NAME	DATE
ORIGINATOR	MERLE HALDEMAN	11/16/98
DRAWN	BRUCE MERKEL	11/16/98
CHECKED	TOM CRENNA	1/8/99
APPROVED

FERMILAB PPD/ETT/ES CDMS (E-891)
ZIP MODULE
EXTERNAL TEST RECEIVER

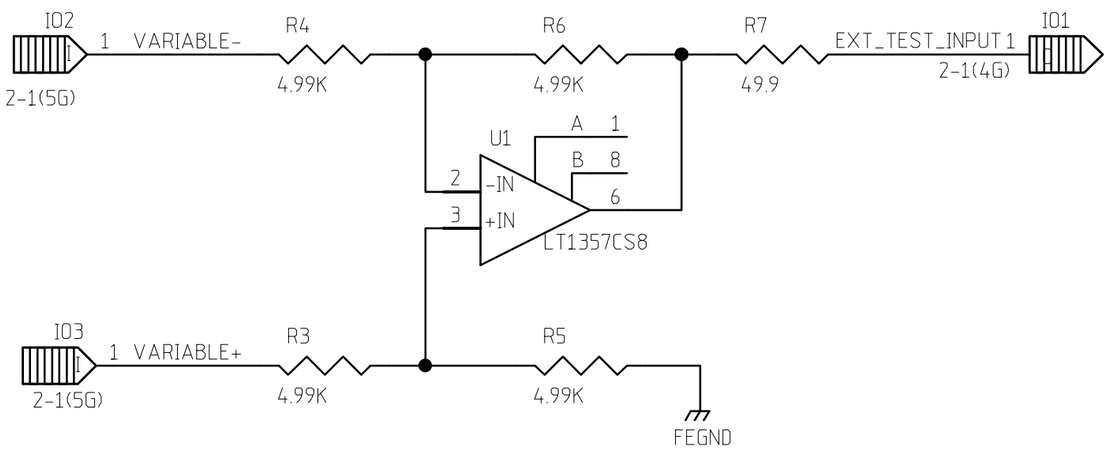
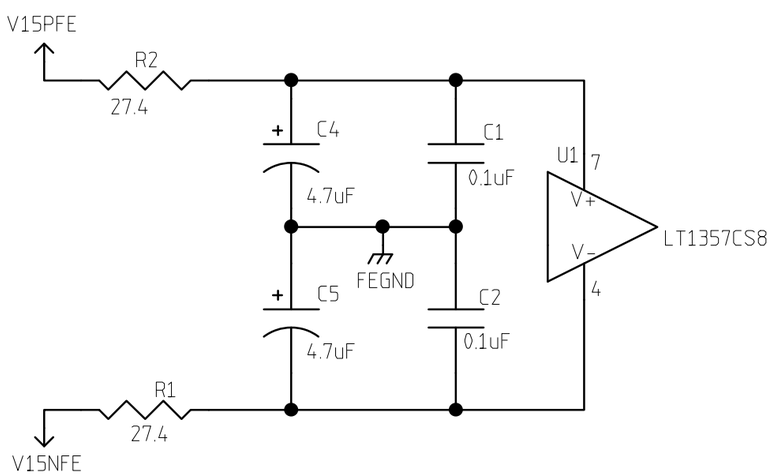
REVISIONS			
REV	DESCRIPTION	DATE	APPROVED
A	CHANGED U1 FROM ANALOG DEVUCES SSM2141S TO LINEAR TECHNOLOGY LT1357CS8 FOR FASTER RESPONSE ALSO ADDED TWO 4.7uF CAPS TO BYPASS	4/28/99	M.HALDEMAN
